PAUL MEW ASSOCIATES
TRAFFIC CONSULTANTS LTD

REBUTTAL NOTE

Author:	Emily Scott - Holt; Paul Mew
Date:	December 2015
Project:	PI364: 45 Maresfield Gardens
Subject:	Rebuttal Note

Proposed Crossover Layout Options 45 Maresfield Gardens Enforcement Appeal

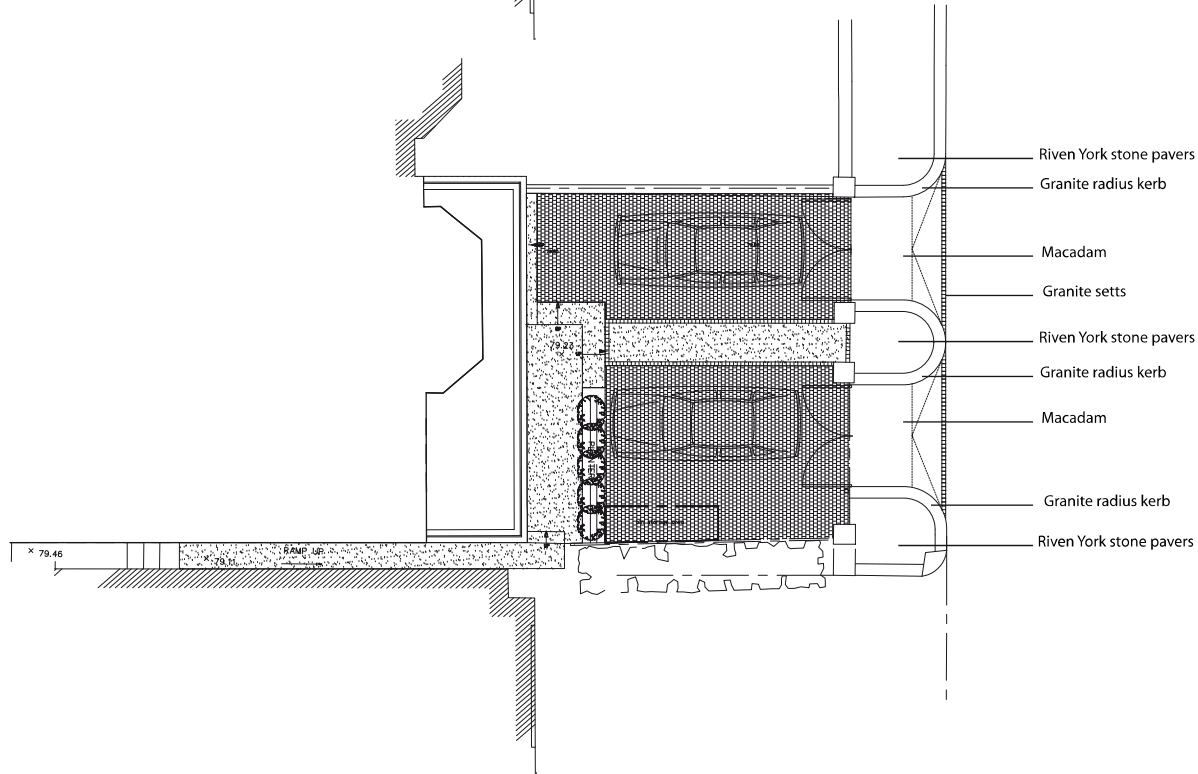
“The forecourt layout creates an excessive distance between points of safety for pedestrians on the footpath.”

30. The proposed crossover has been designed in two ways, as a large single crossover, and as two smaller crossovers with a central refuge for pedestrians, refer to Appendix B. Both crossovers are considered to be appropriate and in keeping with other crossovers on Maresfield Gardens, however the provision of a pedestrian refuge between two smaller crossovers is a safer design for pedestrians, by providing shelter from vehicles using the crossover.

31. Given the low frequency of vehicle movements across the crossover, and the precedent of long crossovers already on Maresfield Gardens, neither of the crossover designs are considered to create *“an excessive distance between points of safety for pedestrians on the footpath”*.

PI364: 45 Maresfield Gardens, London, NW3 5TE
 Appendix C.
 Swept Path Analysis: Estate Car

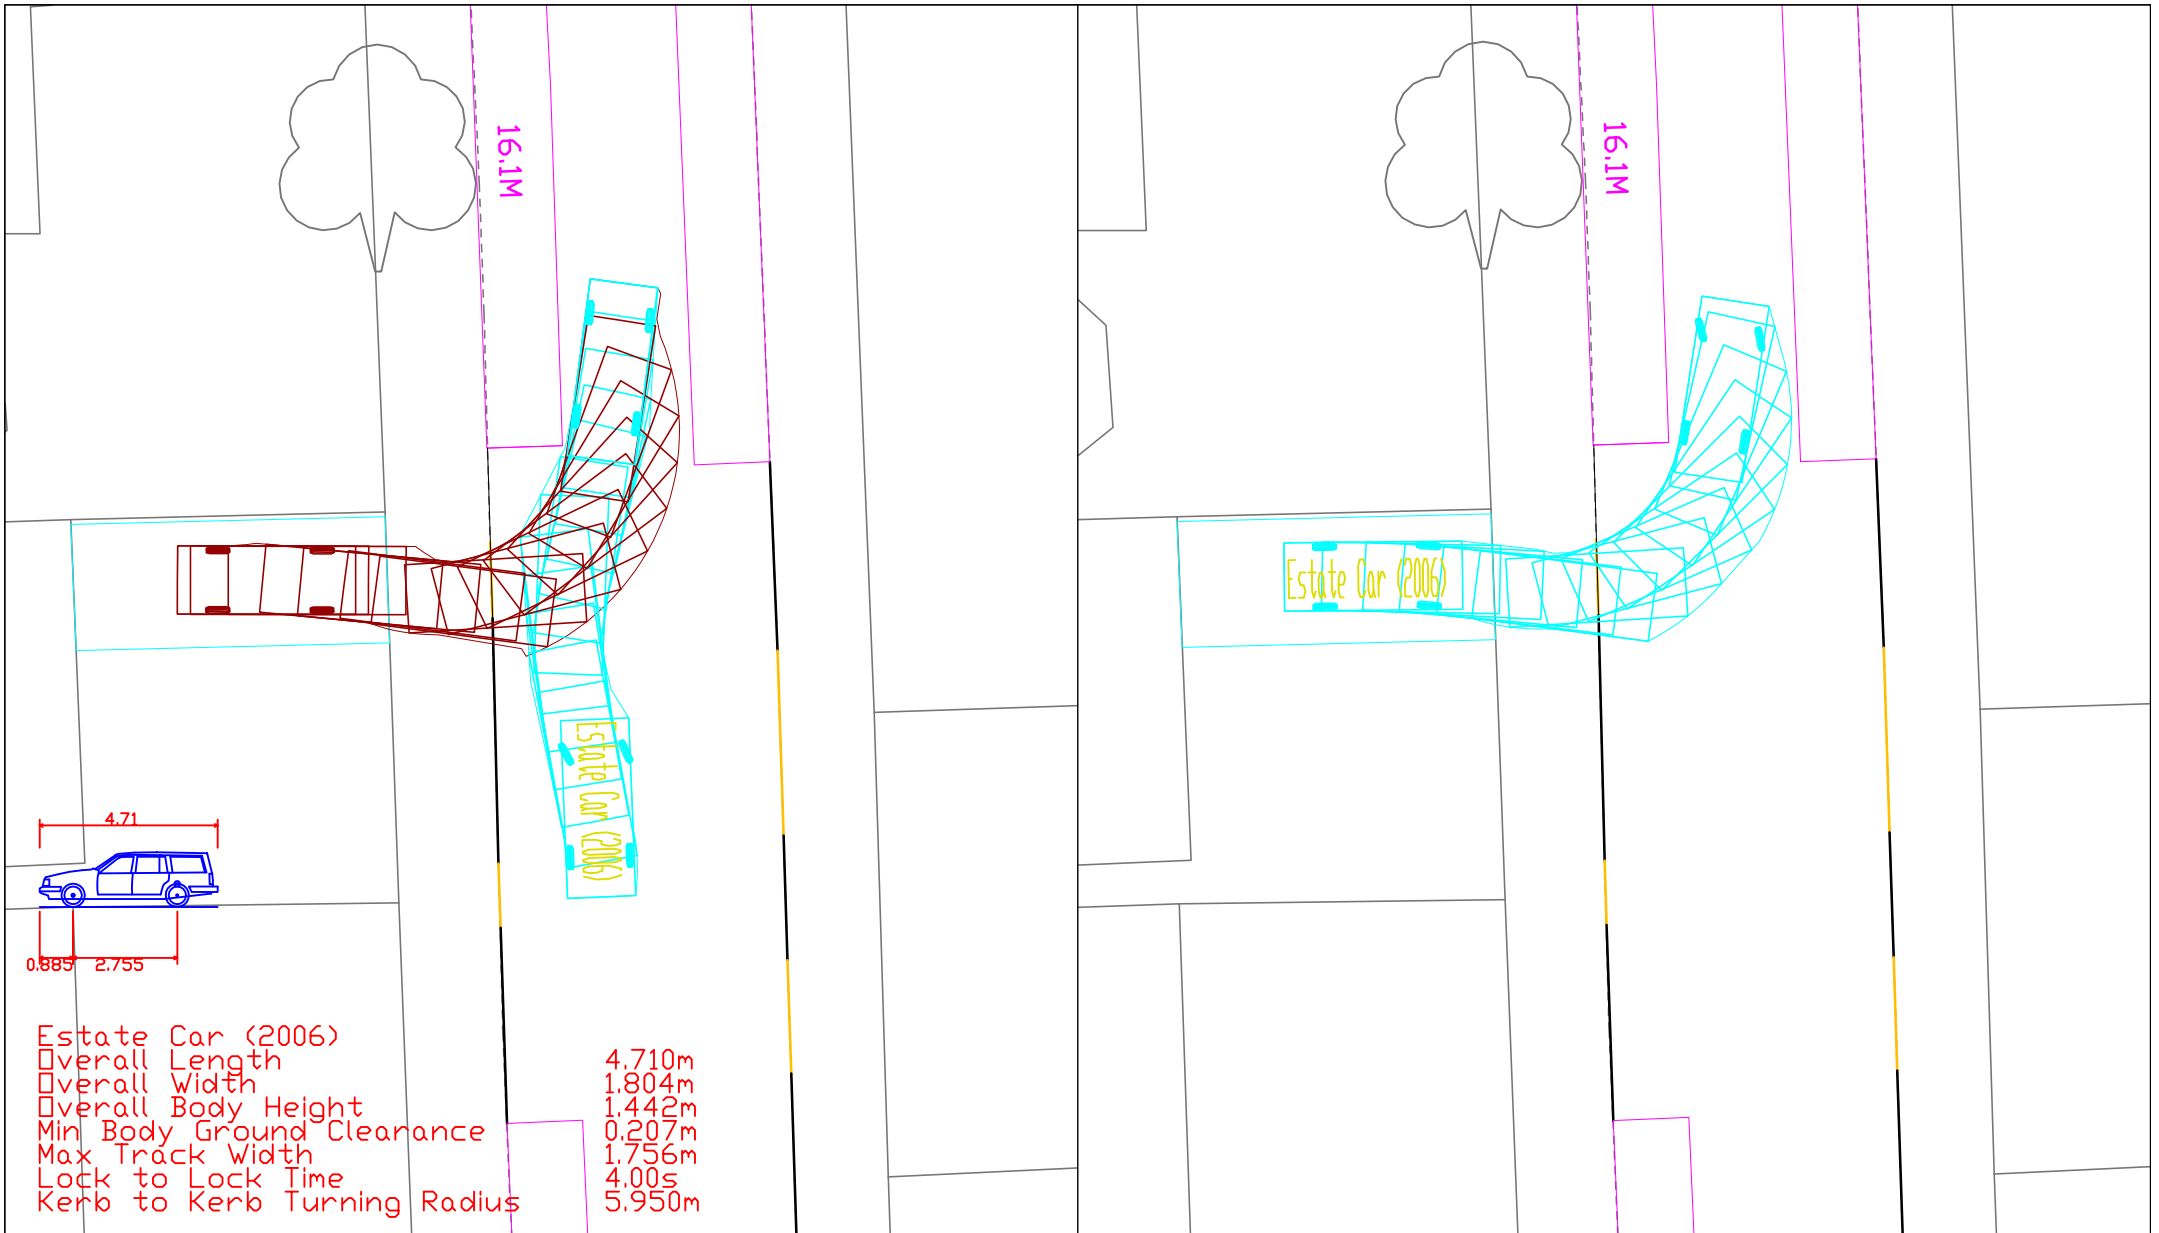
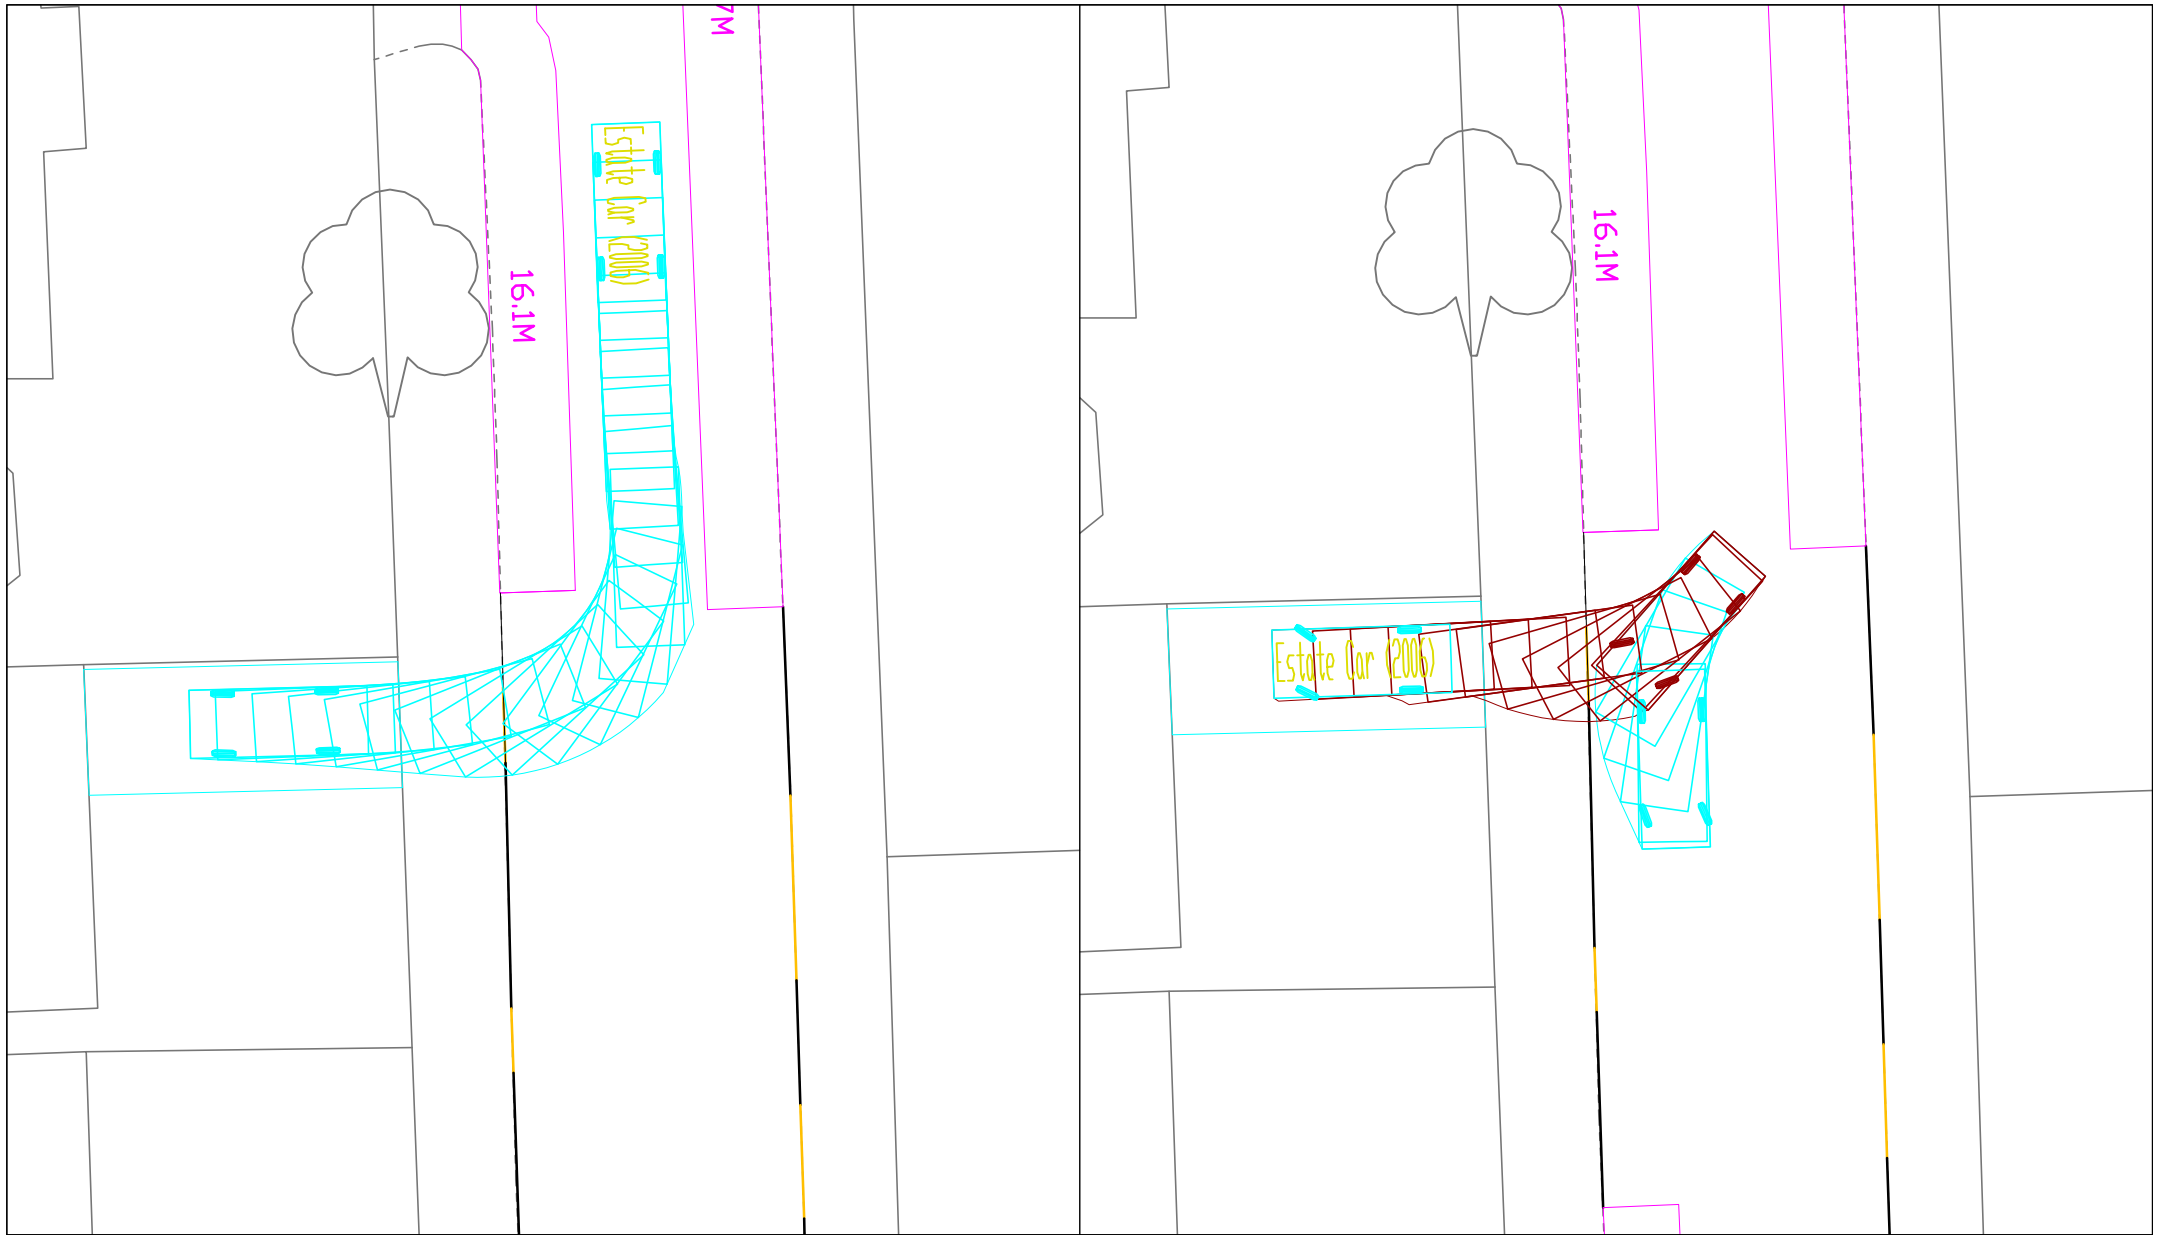
“Vehicles using the parking opportunity are unable to enter from the north, and exit left without crossing to the other side of the road.”

“The swept path analysis has not taken into consideration the location of on-street parking bays.”

35. Swept path analysis has been conducted to demonstrate that a vehicle is able to enter the forecourt parking opportunity when approaching from the north, and exit to the north, without crossing the other side of the road or any PHO parking bays. Refer to Appendix C.

36. A large estate car has been used in the swept path analysis to demonstrate that the manoeuvres are possible with an above average length of vehicle.
